UNITED STATES  
NUCLEAR REGULATORY COMMISSION  
WASHINGTON, D. C. 20555

SAFETY EVALUATION BY THE OFFICE OF NUCLEAR REACTOR REGULATION  
RELATING TO THE PROPOSED SAFE SHUTDOWN SYSTEM  
AND EXEMPTION REQUESTS CONCERNING 10 CFR PART 50, APPENDIX R  
FORT ST. VRAIN NUCLEAR GENERATING STATION  
PUBLIC SERVICE COMPANY OF COLORADO  
DOCKET NO. 50-267

FIGURE 2.1-8  
SIMPLIFIED FLOW DIAGRAM  
CONDENSATE PUMP FOR CIRCULATOR DRIVE  
& S/G COOLING - TRAIN A

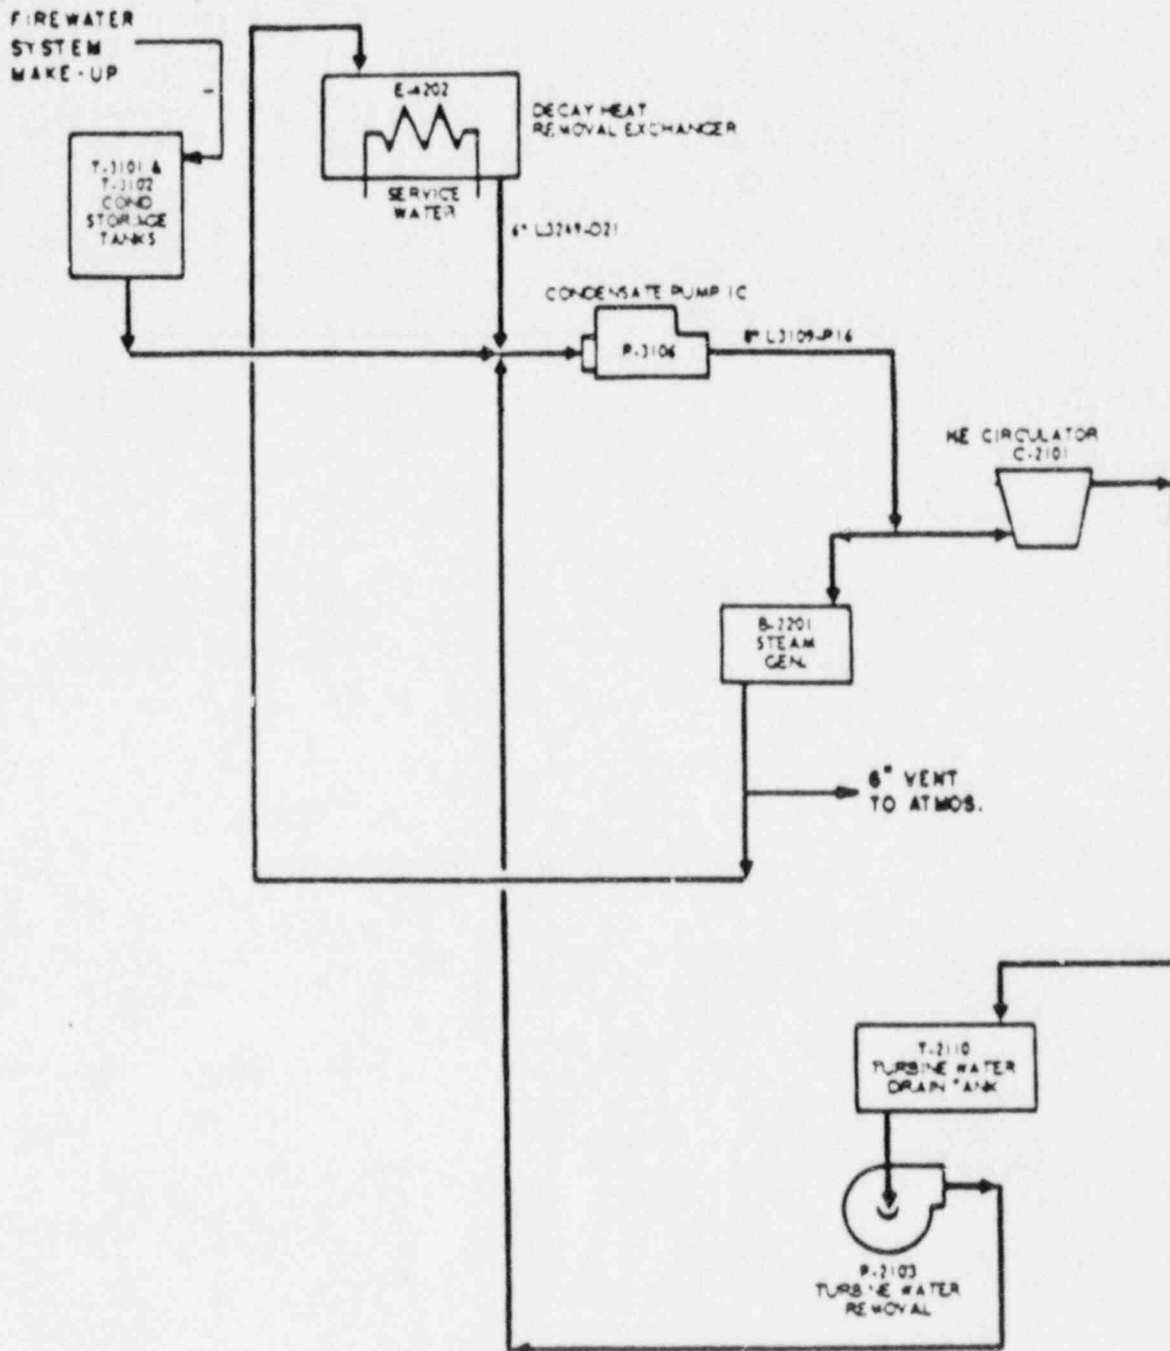
Train A - Condensate Pump 1C provides condensate flow from the Condensate Storage Tank through a steam generator to atmosphere for the first 5 hours after shutdown. Thereafter, the flow from the steam generator is recirculated through the DHR Exchanger. The Condensate Pump 1C also provides flow through a helium circulator.

These flow paths are shown schematically in Figures 2.1-8 and 2.1-9 in Reference 18, copies of which are included in this evaluation as Attachments 1 and 2. A discussion of various aspects of these flow paths is contained in the following paragraphs.

- 1) The electrical power supplies utilized are the ACM diesel generator (DG) for Train A components and Emergency Diesel Generator (EDG) set B for Train B components. The use of the ACM DG was necessitated by the lack of sufficient separation between the A and B EDG electrical cables. The proposed ACM DG electrical flow path runs from the 4160 volt ACM bus to the HVAC switchgear bus, to its feeder supply at the Reserve Auxiliary Transformer, through the feeder to the 4160 volt switchgear Bus 2 where it can be cross-connected to either Bus 1 or 3. The 4160 volt buses provide power to their associated, essential, 480 volt buses (1, 2, and 3). The EDG's provide power directly to the associated 480 volt essential bus; EDG A to Bus 1, EDG B to Bus 3. (These flow paths can be seen on Figure 8.2-5 of the FSV FSAR.)

- 2) The effectiveness of the flow paths through the steam generators in the proposed post-fire shutdown model was questioned in Reference 3. The requested analyses were submitted by PSC letters dated February 17, 1987 (P-87055), and May 1, 1987 (P-87158) (References 16 and 17). Based on a review of the available information, the conceptual designs of the flow paths are acceptable provided: (a) the above analysis verifies the effectiveness of the flow path, and (b) sufficient makeup water capability is demonstrated. The review of these analyses will be the subject of a separate Safety Evaluation.

The proposed means to provide electrical power are acceptable. The adequacy of procedures, testing and training will be verified during routine inspection activities.

FIGURE 2.1-9  
 SIMPLIFIED FLOW DIAGRAM  
 FIRE WATER FOR CIRCULATOR DRIVE & S/G COOLING -  
 TRAIN B

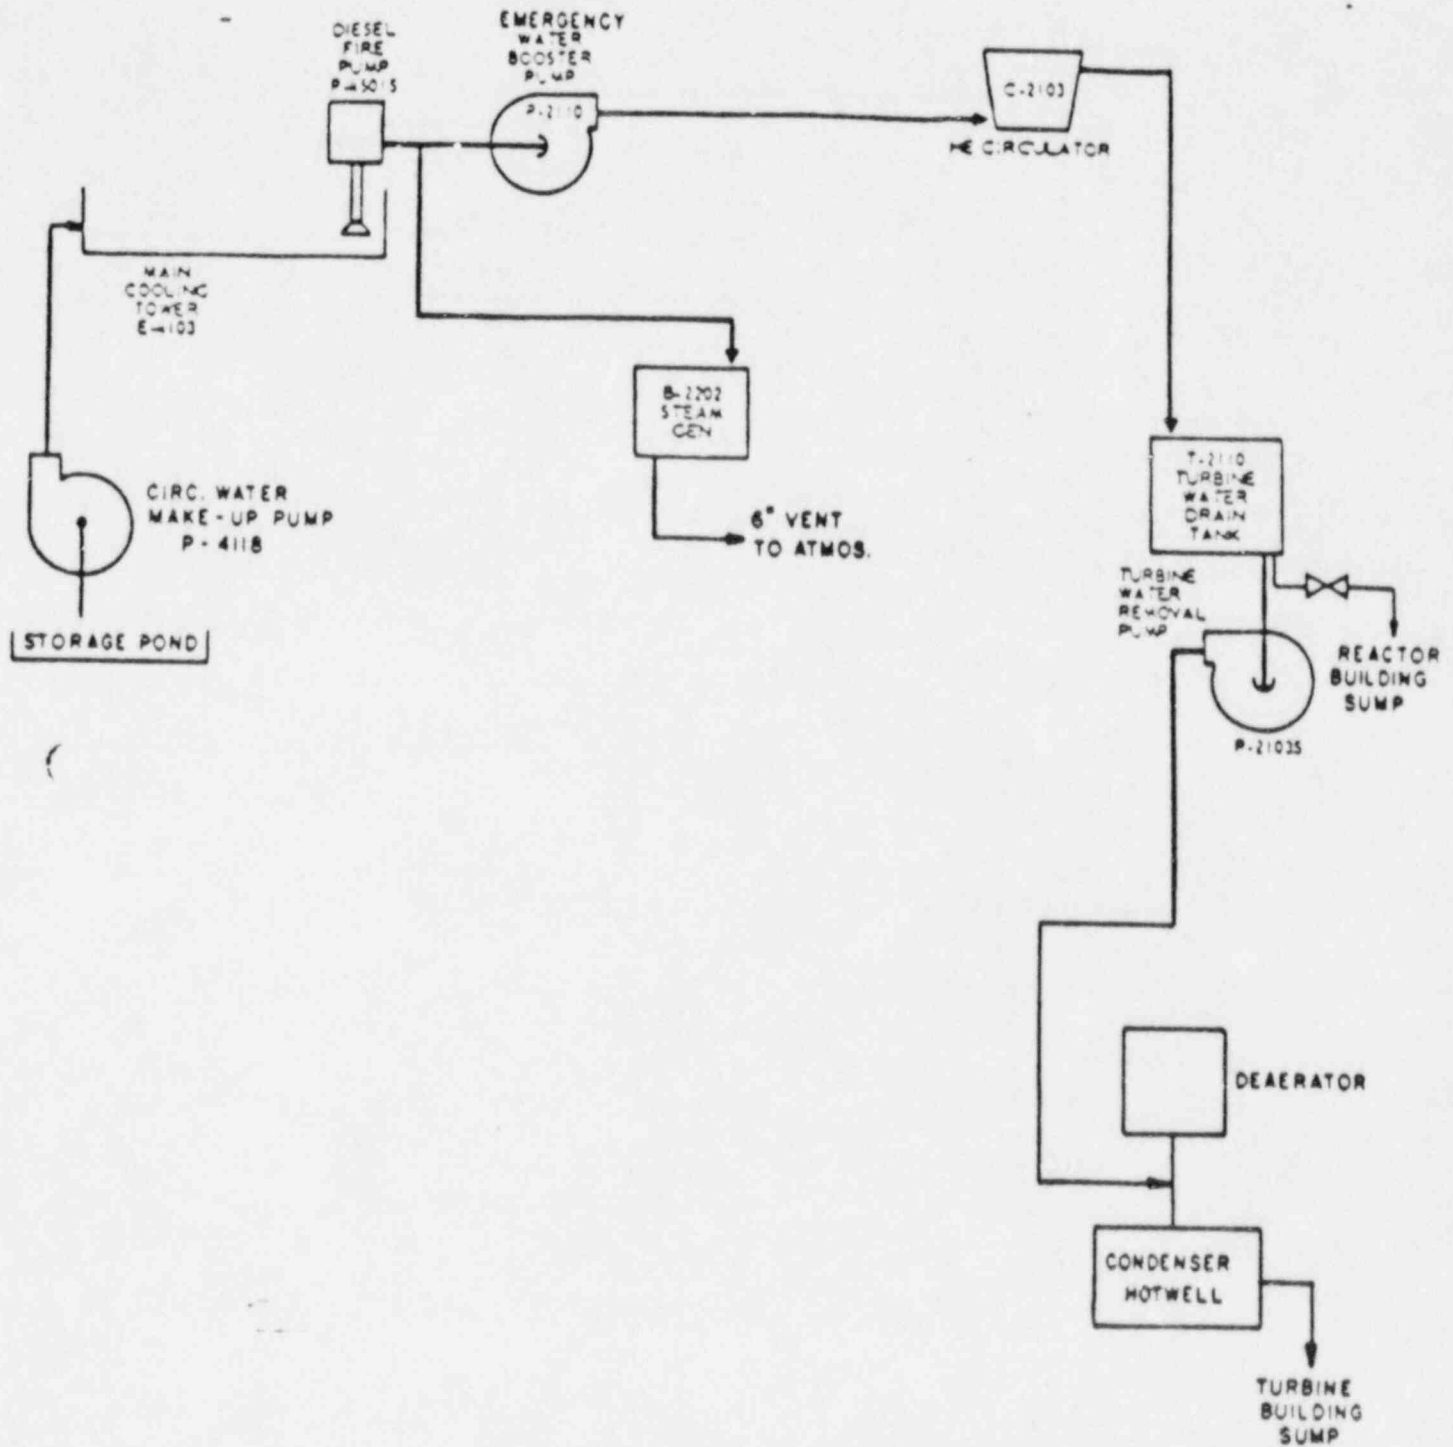
Train B - The diesel driven fire water pump provides flow from the main cooling tower through a steam generator and a helium circulator. These flows are vented to the atmosphere and returned to the turbine building sump, respectively.

- 4) Both post-fire shutdown trains provide for the operation of one Helium Circulator to transport the heat in the reactor core to the steam generators; Train A utilizes condensate flow directly, Train B utilizes fire water through the Emergency Water Booster Pump to drive the circulator's water turbine. A review of FSAR Section 14.4.2.1, indicates that "One helium circulator can provide nearly 4.5% of rated flow through the reactor core when operated by itself with condensate water supplied to this water-turbine drive." However, for Train B, operating on boosted fire water, approximately 3% of rated helium flow can be achieved. Based on this information (References 16 and 17), the primary flow requirement can be met.

FIGURE 2.1-10  
SIMPLIFIED FLOW DIAGRAM  
BEARING WATER FOR CIRCULATORS

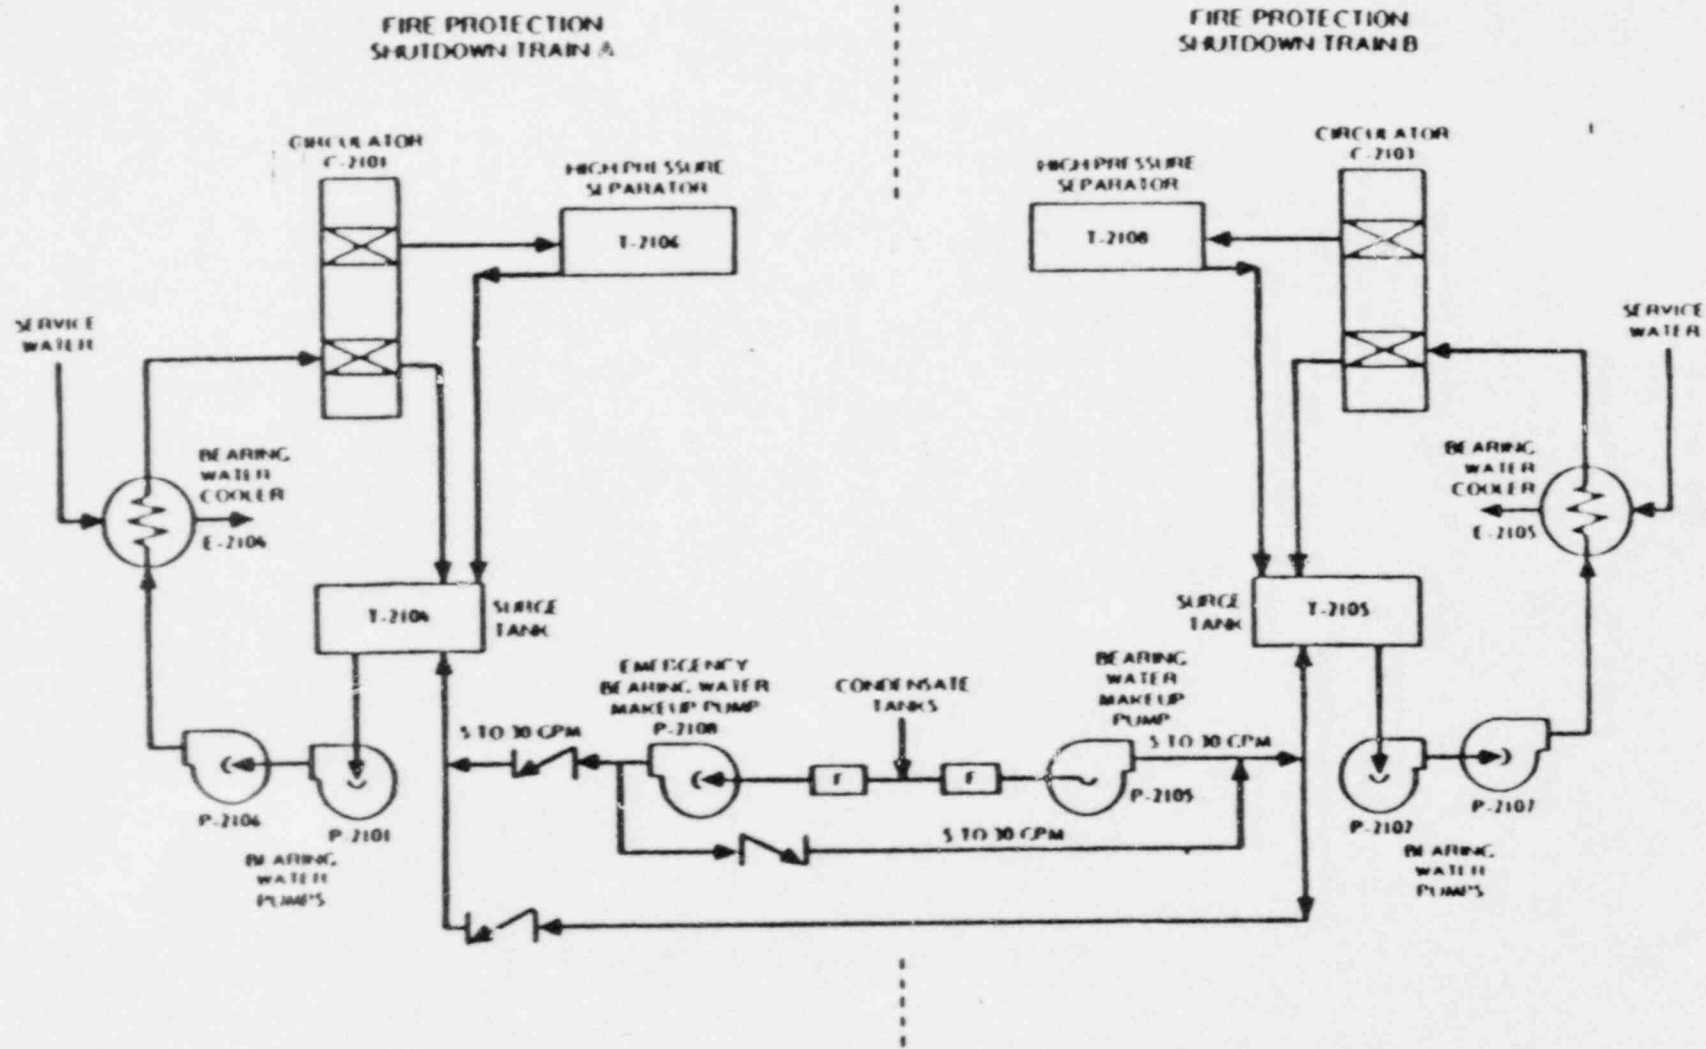
A review of the ability to operate the circulators with the proposed auxiliary equipment (see Attachment 3 for flow diagram) disclosed provisions for providing bearing water but not for providing a source of the buffer helium for shaft sealing. The PSC response (Reference 4, Item 8) addressing the acceptability of operating a circulator without buffer helium indicates that tests which were conducted showed that there would be little effect on either helium egress or water ingress. Therefore, the bearing water system is adequate.

The makeup source to the bearing water system is from the condensate tanks via the Emergency Bearing Water Makeup Pump for Train A and the normal Bearing Water Makeup Pump for Train B, both of which can be cross connected. While the makeup systems appear to be acceptable, the power supply cables lack the required separation. The licensee proposed modifications which will result in greater physical separation of the cables. These modifications have been reviewed and found acceptable as discussed in our evaluation of the exemption request for the Reactor Building (See Section 2.9).

PSC will permanently install a third Turbine Water Removal Pump a minimum of 50 feet from the existing tank and pumps. This pump will be used in normal plant operation and also meet the criteria of redundant Appendix R emergency shutdown equipment.

FIGURE 2.1-11A  
SIMPLIFIED FLOW DIAGRAM - SERVICE WATER SYSTEM - TRAIN A

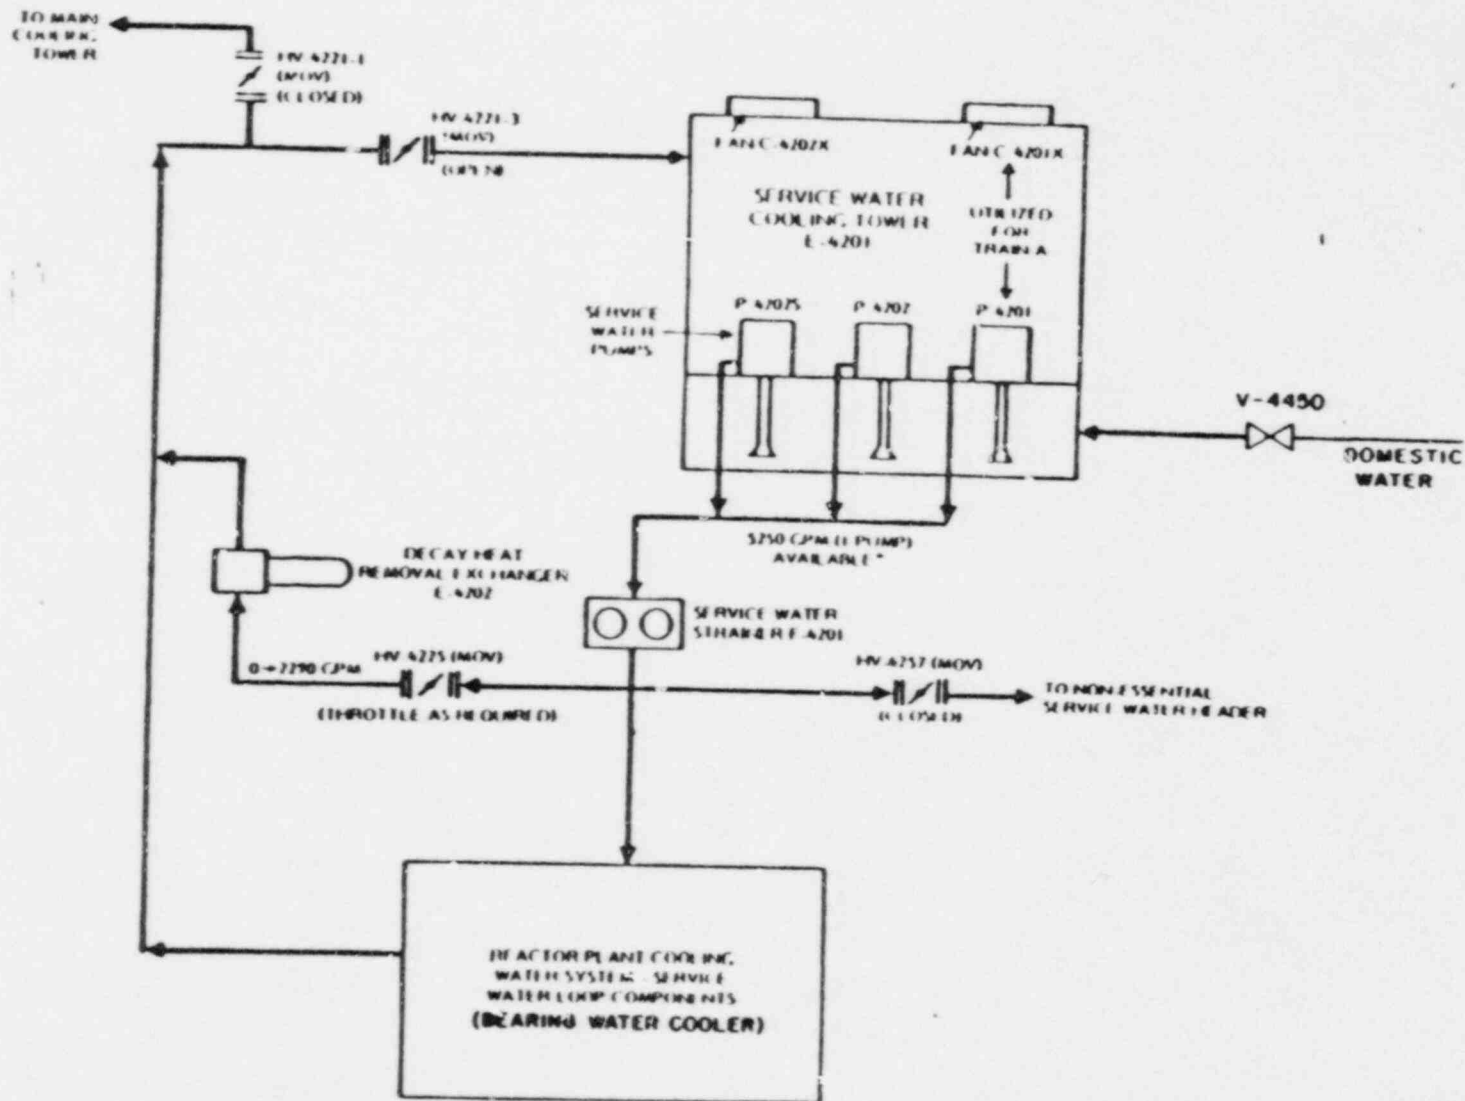
As discussed above, secondary heat is removed in Train A through the use of the DHR Exchanger where the decay heat, which was transferred to the feedwater in the steam generators, is transferred to the service water system. The service water models are shown schematically in Figures 2.1-11A and 2.1-11B of Reference 18. These figures are included as Attachments 4 and 5.

- 1) The Train A service water (SW) system utilizes a SW pump to provide flow from the SW cooling tower through the SW strainer to the various system cooled components or "loads." The return path from these loads is back to the SW cooling tower where one of the SW cooling tower fans is operated to reject the heat to the atmosphere. Makeup flow to the SW cooling tower is provided from the domestic water supply. The SW pump and the tower fan can all be powered from the ACM DG.

- 3) PSC provided a discussion of single failure considerations for components common to both proposed trains of SW in Reference 4, Item 1. In particular, the SW strainer and the flow control valves to the various loads were addressed. Since these components are water-filled mechanisms which can be manually operated, their use was determined to be acceptable.

FIGURE 2.1-11B  
SIMPLIFIED FLOW DIAGRAM - SERVICE WATER SYSTEM - TRAIN B

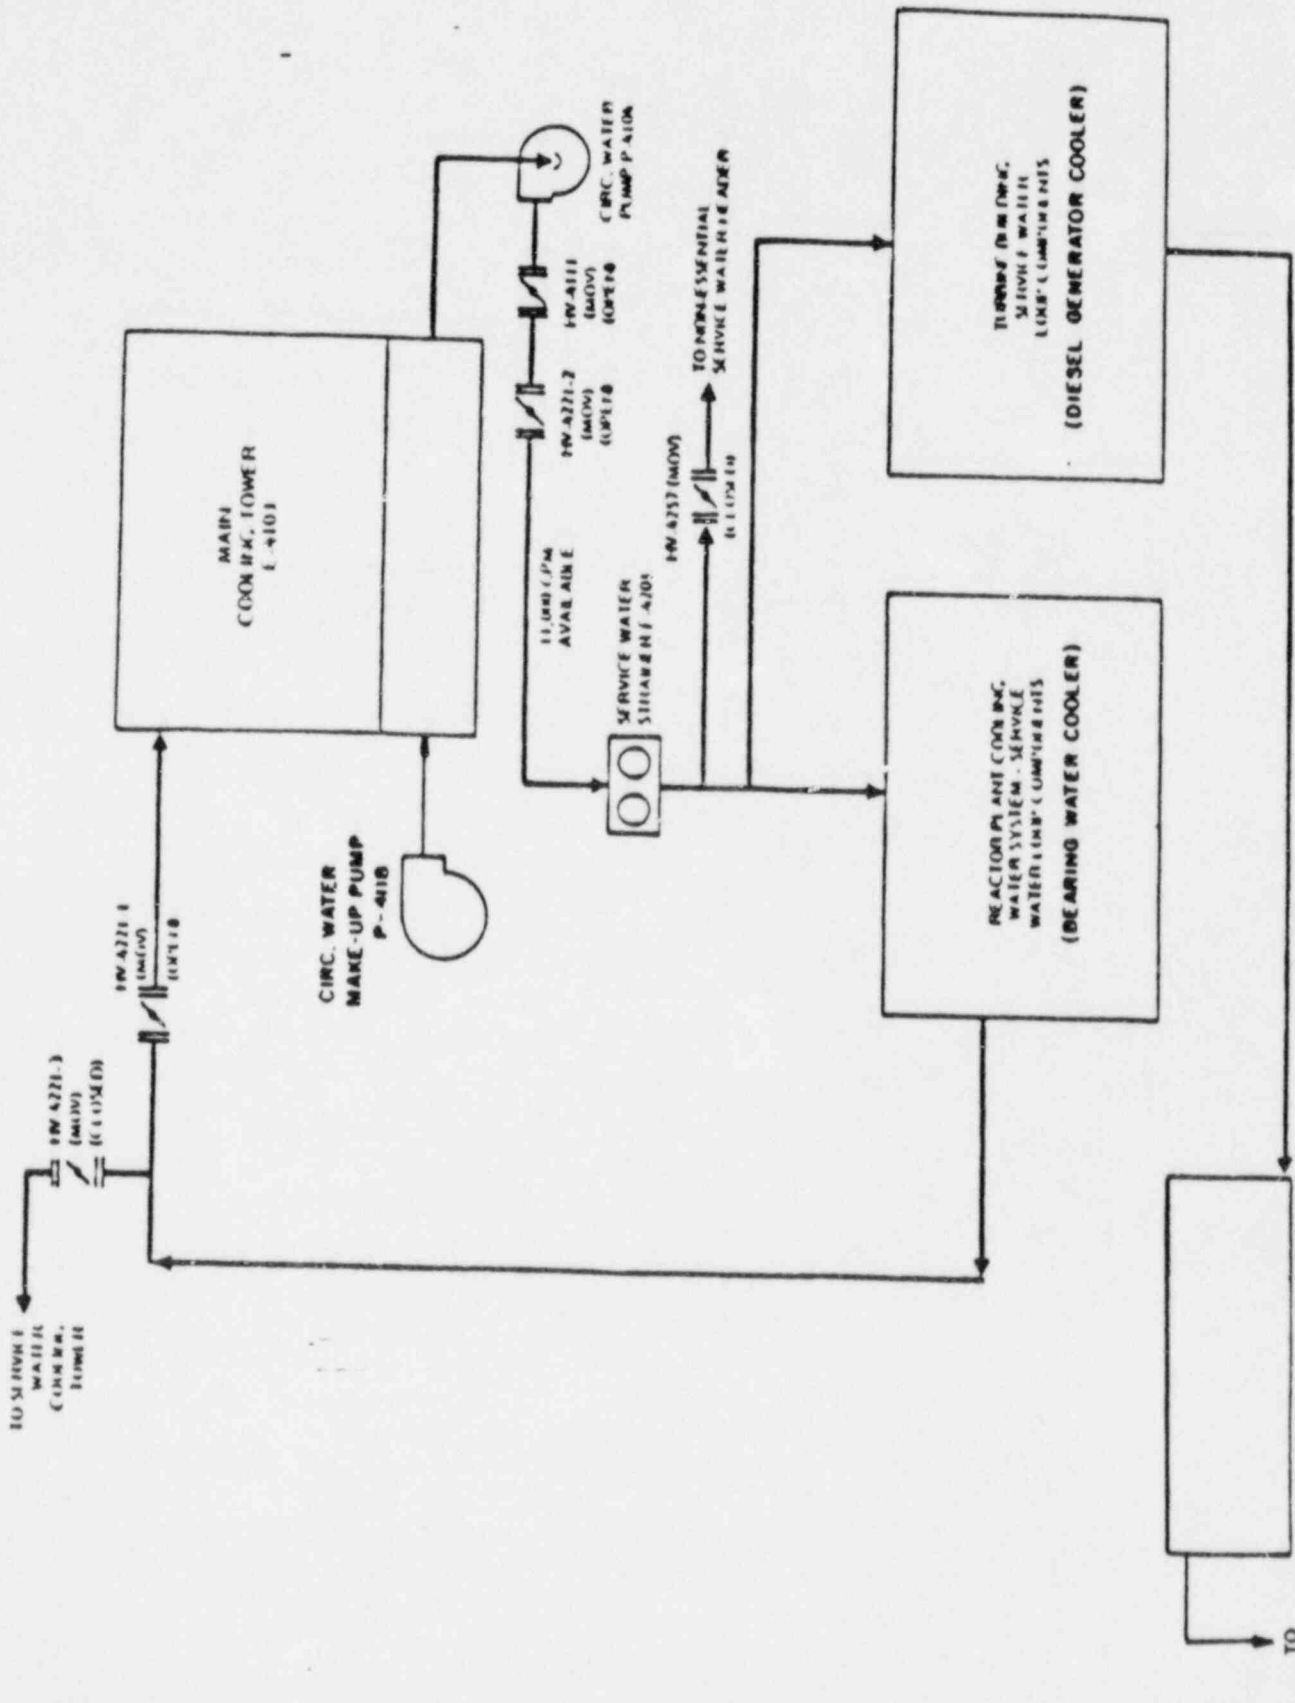
- 2) The Train B SW system utilizes a circulating water pump to provide flow from the Main Cooling Tower to the SW system, through the various loads, and back to the tower. The licensee's evaluation of the need for operating a Main Cooling Tower Fan is contained in Reference 4, Item 5. This evaluation, performed before the DHR Exchanger heat load was deleted from the Train B model, concludes that cooling assistance is not required. If cooling is desired, either (a) makeup water may be added or (b) a fan may be operated.
